ALERT SERVICE BULLETIN

429-16-29

MODEL AFFECTED: 429

SUBJECT: FWD CENTER FIREWALL WELDED ASSEMBLY 429-069-501-101/-109/-113 AND AFT CENTER FIREWALL WELDED ASSEMBLY 429-069-504-101/-103/-105/-107, INSPECTION AND REPAIR OF

Figure 3 – Part II - B (Sheet 1 of 5)

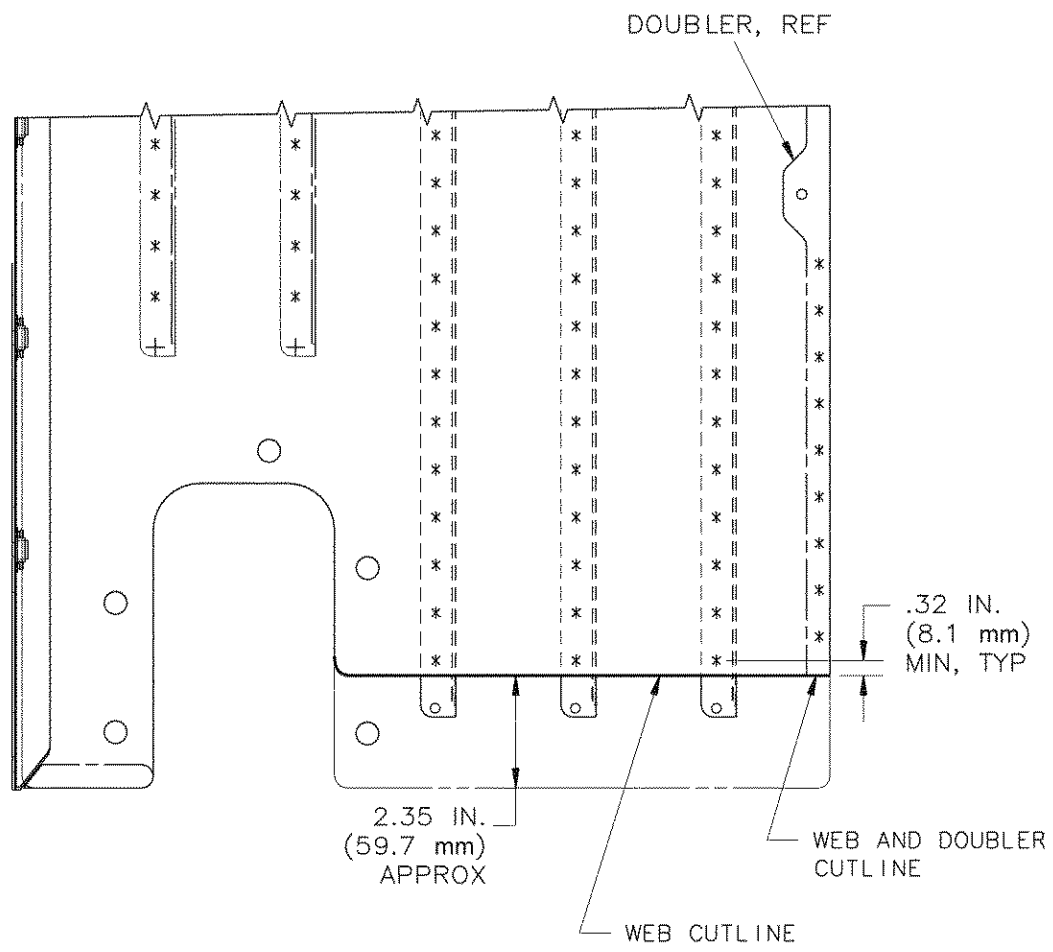
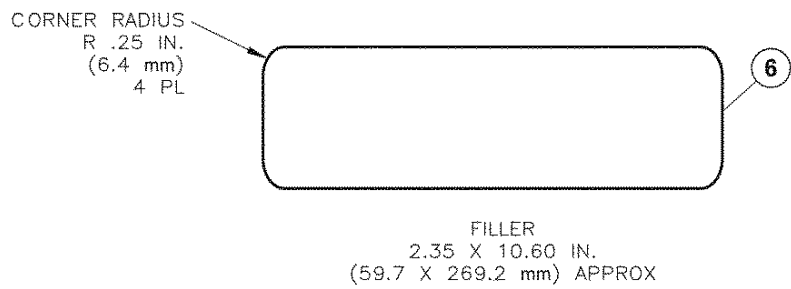
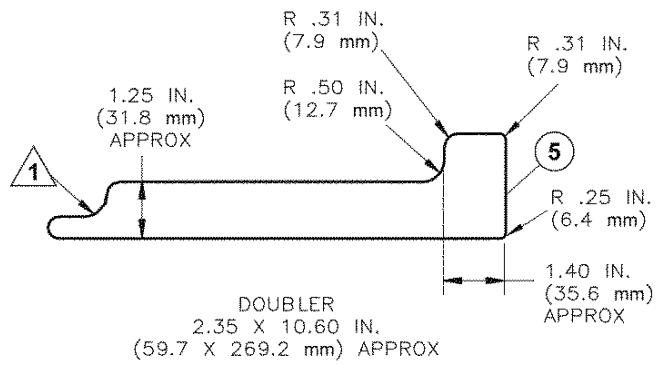
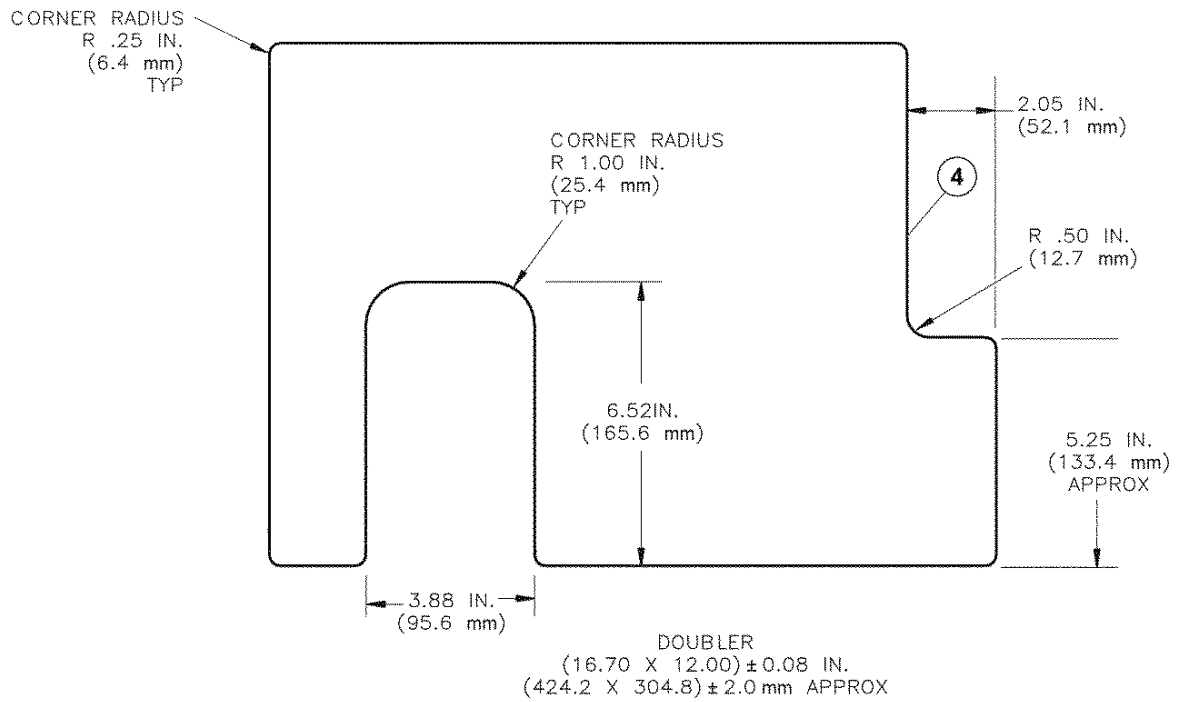
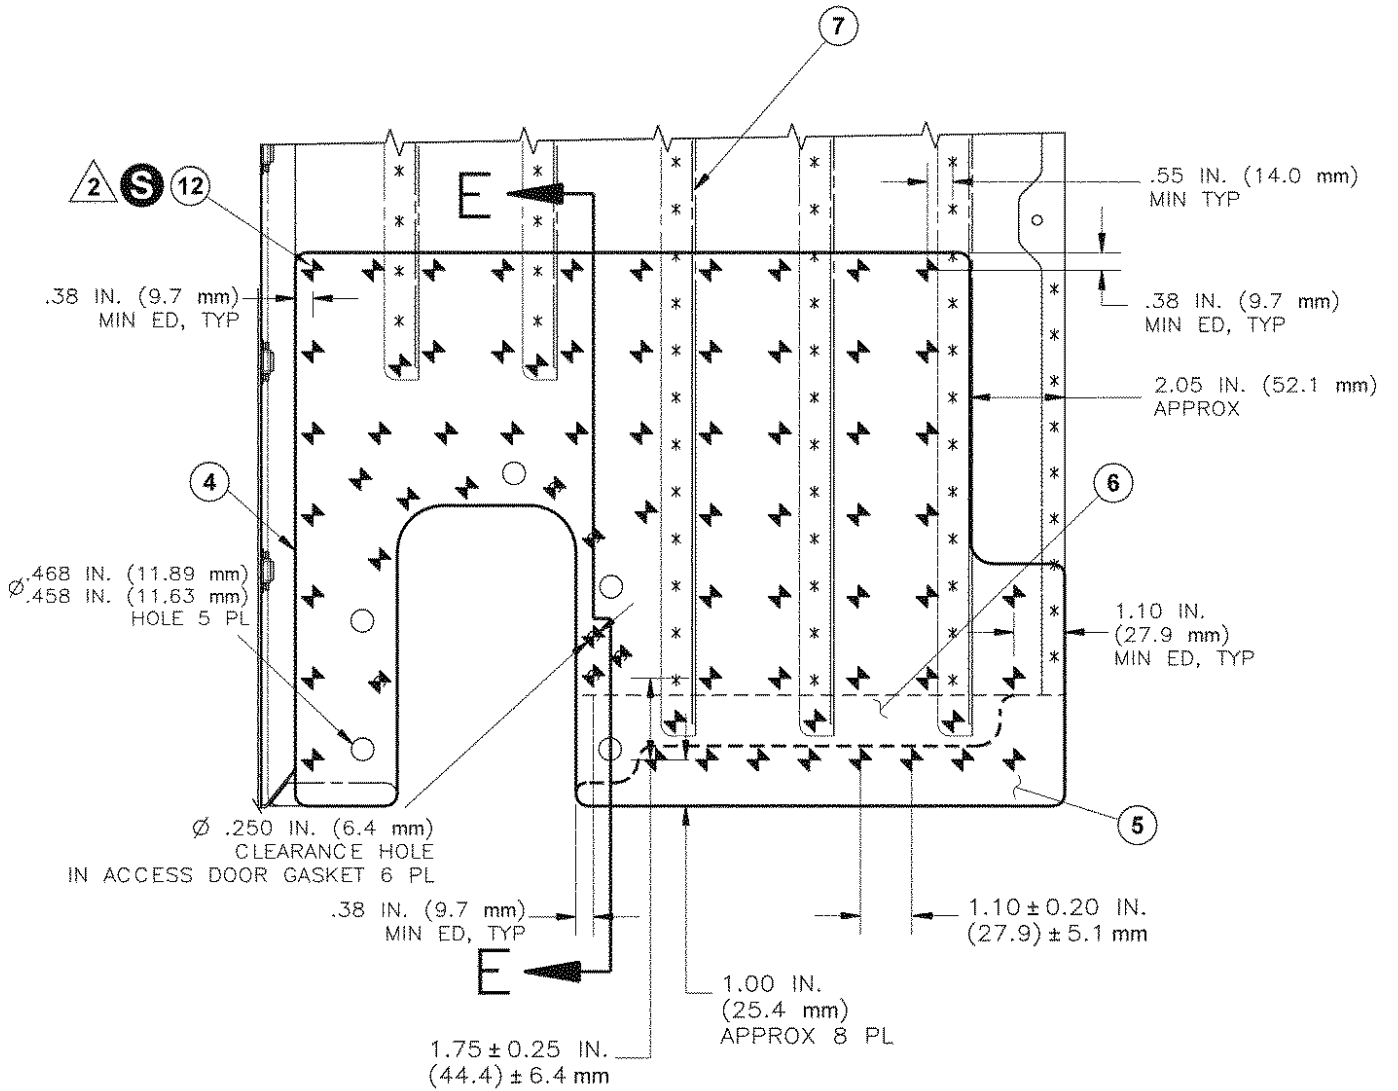
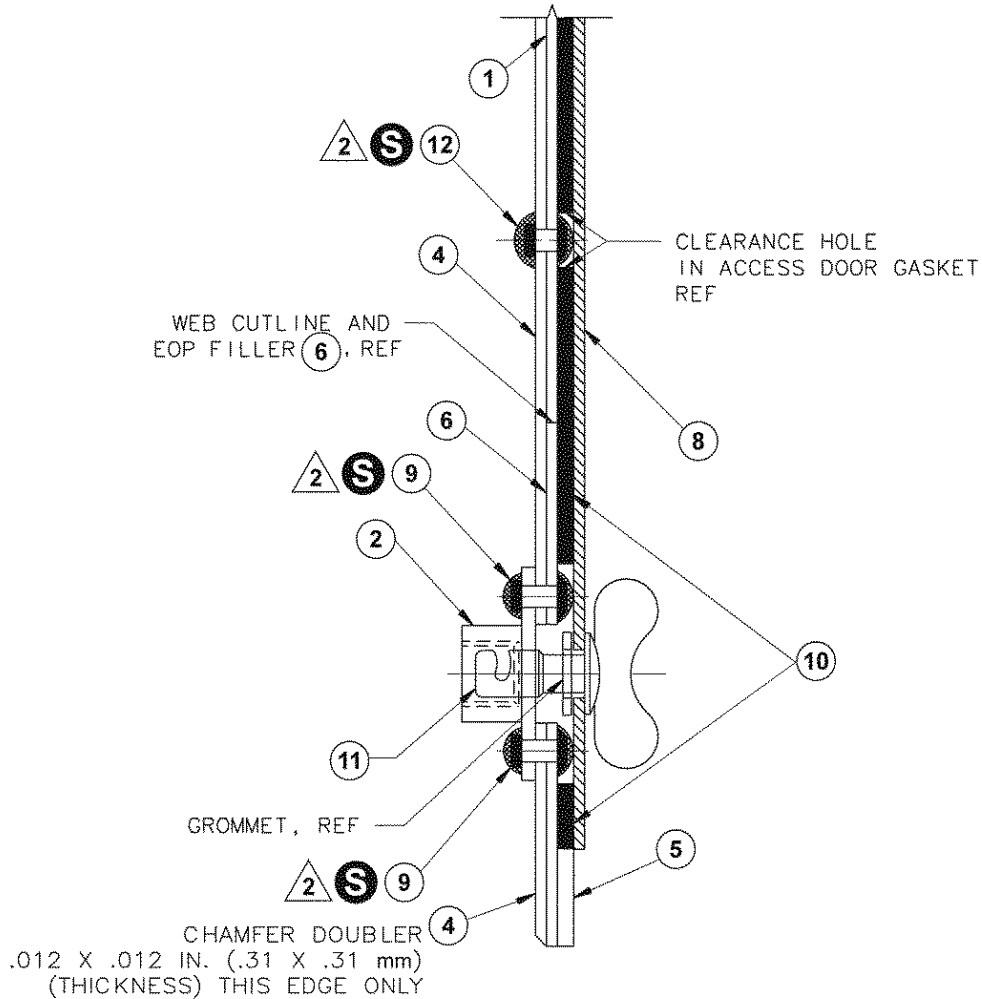
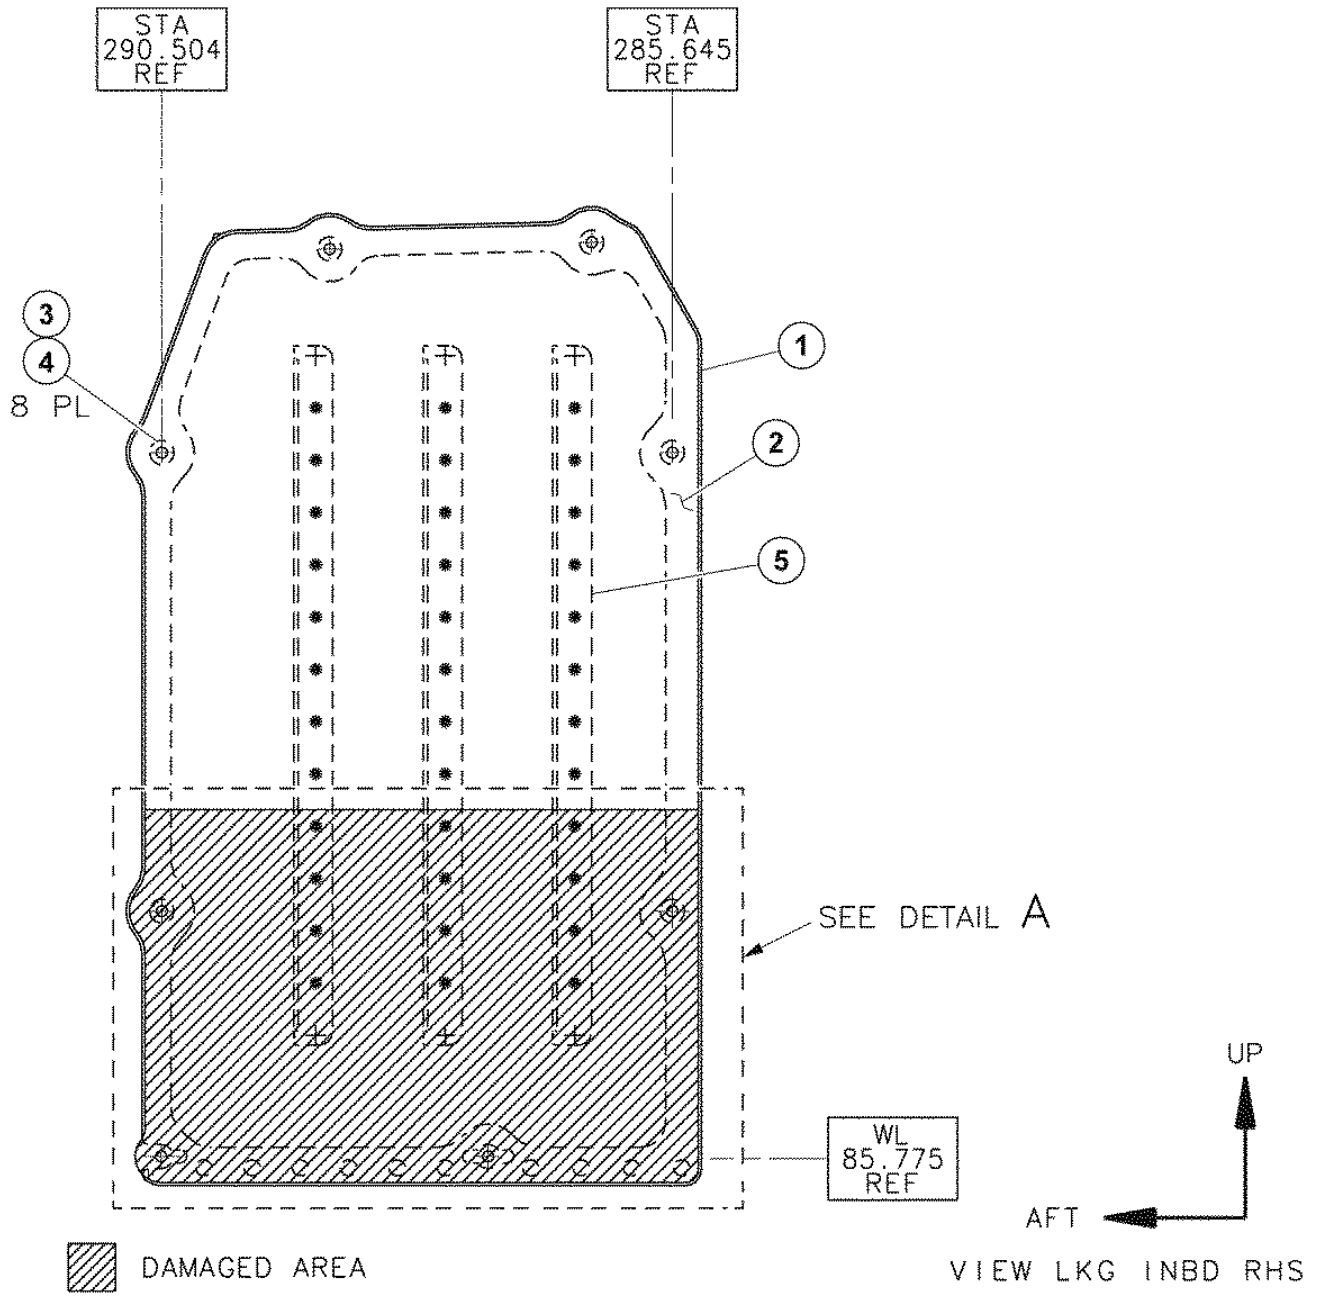
Part II - A is applicable to firewall assembly 429-069-501-101/-109. **Part II - B** is applicable to firewall assembly 429-069-501-113.

3. Cut out and remove the damaged portion of the FWD center firewall welded assembly (1) and doublers. Cutout to be as per the dimensions shown in Detail B.

4. Inspect the exposed areas of the FWD center firewall welded assembly (1) and the surrounding structure for corrosion, cracks, chafing, or damage. Make sure the spot welds adjacent to the cutline are intact (Detail B). If any such damage exists, submit to PSE with details describing the extent of the damage.

5. Fabricate the doubler (4) using the repair sheet 150-021-31C1-2 and dimensions shown in Detail C.
6. Chamfer the doubler (4), as shown in Section E-E.

7. Fabricate the doubler (5) using the repair sheet 150-021-35C1-1 and dimensions shown in Detail C.
8. Locate the access door panel (8) on the FWD center firewall welded assembly (1).

9. Locate the doubler (5) in position on the FWD center firewall welded assembly (1) and trim to make sure it does not interfere with the access door panel (8) (Detail C, Detail D, and Section E-E).

10. Remove the access door panel (8).
11. Fabricate the filler (6) using the repair sheet 150-021-31C1-2 and dimensions shown in Detail B and Detail C to fit the cutout area in FWD center firewall welded assembly (1).

12. Locate all of the repair parts (4, 5, and 6) in position and drill to accommodate the new fastener locations (Detail D). Make sure proper edge distance and spacing is achieved. Refer to [Table 3-28 of ALL-SRM](#) for the appropriate fastener hole sizes.

13. Transfer the five 0.458 to 0.468 inch (11.63 to 11.89 mm) diameter holes into the doubler (4) and filler (6) (Detail D).
14. Locate the access door panel (8) in position and mark the position of the added fastener holes common to the access door gasket (10) (Detail D, Section E-E). Make sure proper edge distance is achieved.

15. Remove the access door panel (8). Rout a 0.25 inch (6.4 mm) diameter hole on the gasket (10) at the added fastener hole locations (Detail D).

17. Locate and secure all repair parts (4, 5, and 6) using fasteners (12), as shown in Detail D.

18. Locate and secure the receptacles (2) using fasteners (9) (Detail D).

19. Seal all edges of the repair area on the FWD center firewall welded assembly (1) with firewall sealant (C-353). Make sure the edges of the doublers (4 and 5) and the filler (6) are sealed and that the rivet heads and shop heads are overcoated with firewall sealant (Section E-E).
